Addendum 13 – UN Regulation No. 14

Revision 5 - Amendment 6

08 series of amendments – Date of entry into force: 19 July 2018

Uniform provisions concerning the approval of vehicles with regard to safety-belt anchorages

Model A
(see paragraph 4.4. of this Regulation)

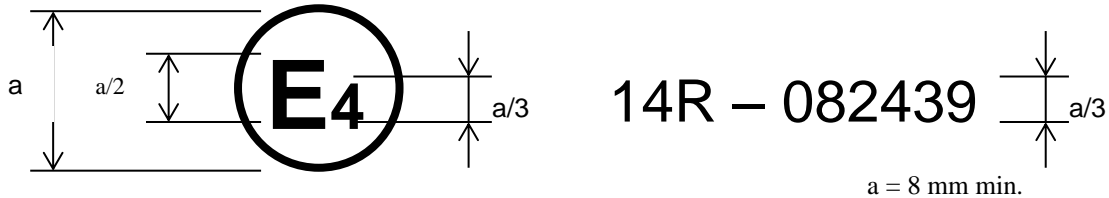
Annex 2, amend to read:

The above approval mark affixed to a vehicle shows that the vehicle type concerned has, with regard to safety-belt anchorages, been approved in the Netherlands (E 4), pursuant to UN Regulation No. 14, under the number 082439. The first two digits of the approval number indicate that UN Regulation No. 14 already included the 08 series of amendments when the approval was given.
